HOSHIZAKI AMERICA, INC.

SERVICE BULLETIN

SB15-0007

Subject: Shutter solenoid 3U0095-01 will be NLA.

Fig. 1

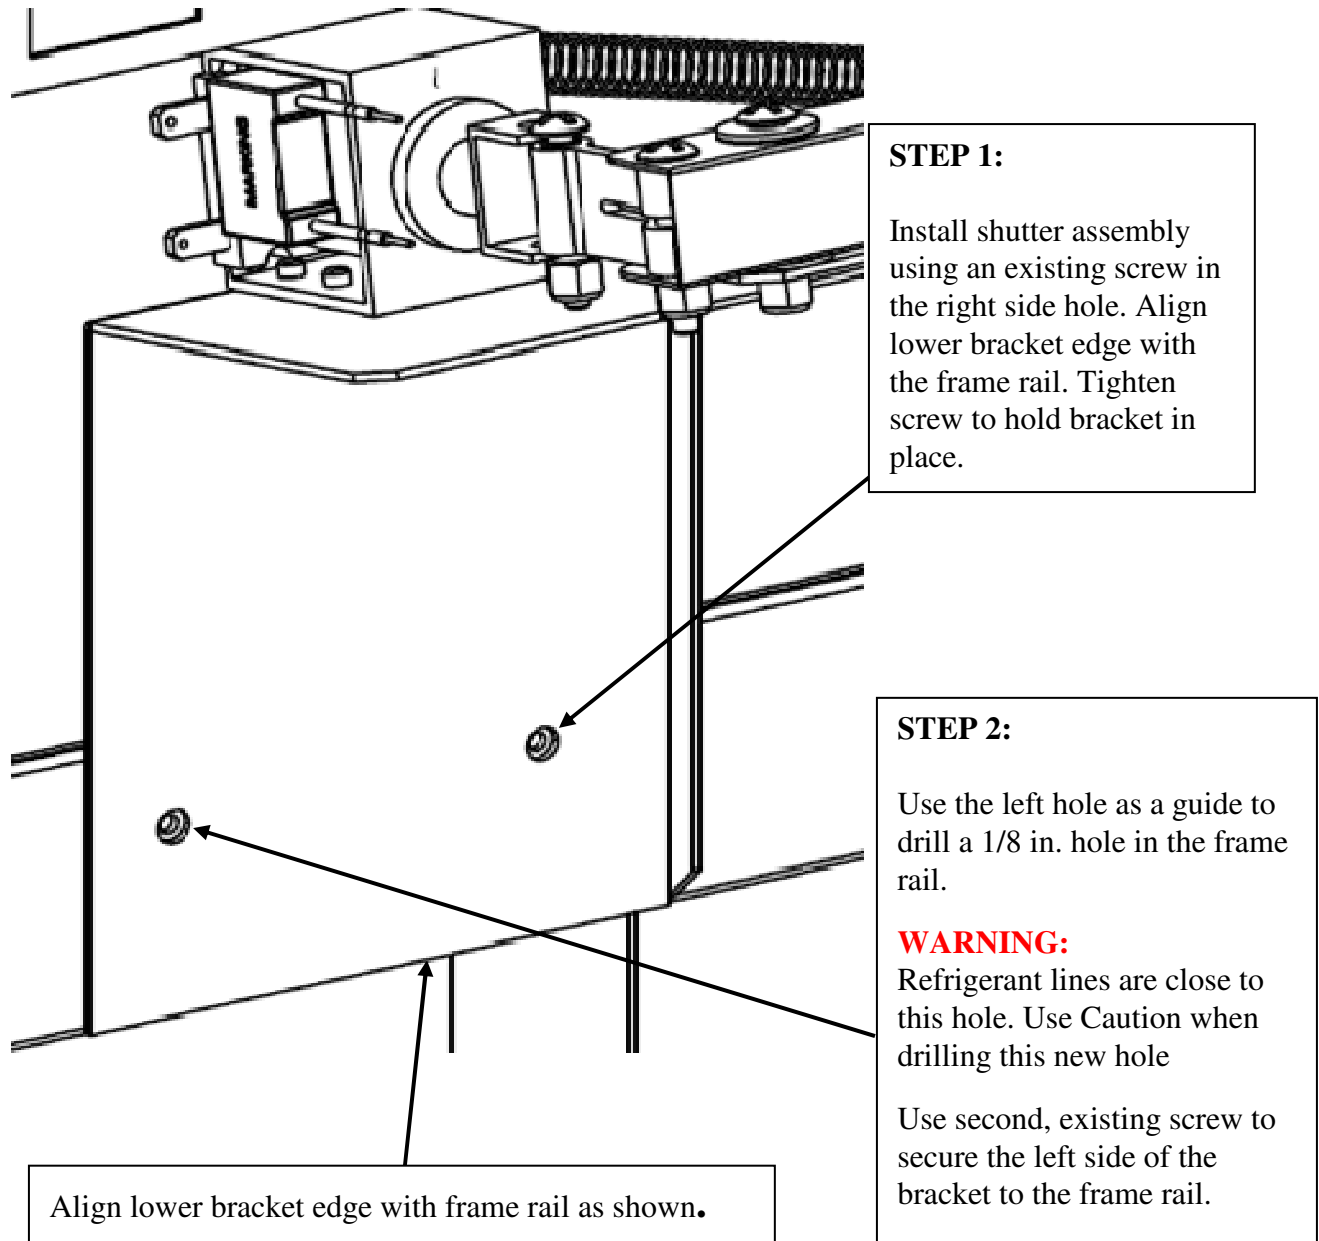
DCM-700, 750 and DCM-751 with serial numbers C _ _ _ _ L and earlier will need additional modification when using the new shutter assembly. For modification instructions see page 2.
